# PERMIT

SEWAGE DISPOSAL SYSTEM

MARYLAND STATE DEPARTMENT OF HEALTH

A SEWAGE DISPOSAL-SYSTEM LOCATED AT College Avenue

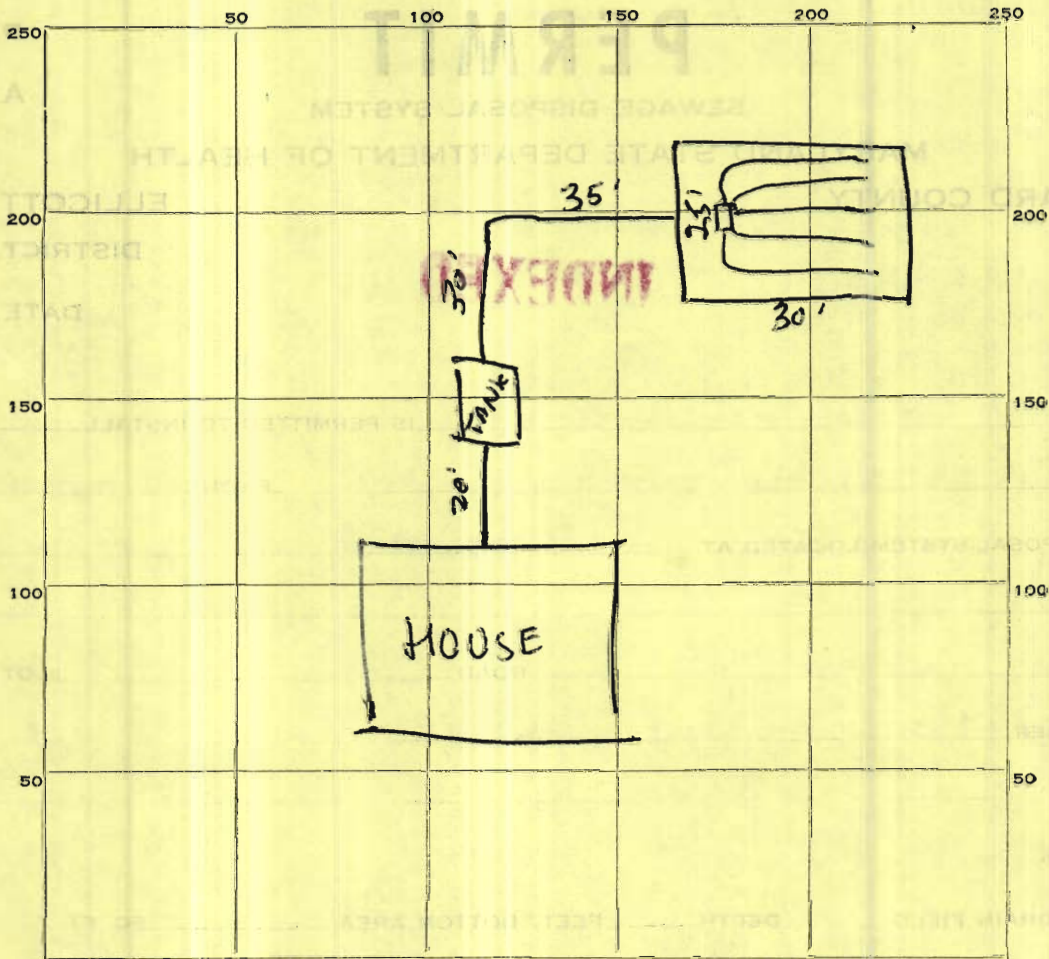
OTHER Leaching bed 20 ft. wide by 25 ft. long located 20 ft. from side wall and 58 ft. behind rear wall of house. This will place the bed on that side of the lot which is closest to College Ave.

REMARKS leaching bed 30' x 25' = 750 S.F.

7/28/61 - no distribution box apparent in bed at time of inspection, or, if present, under at least 1' of gravel. (w/c)

7/31/61 - saw distribution box. (w/c)
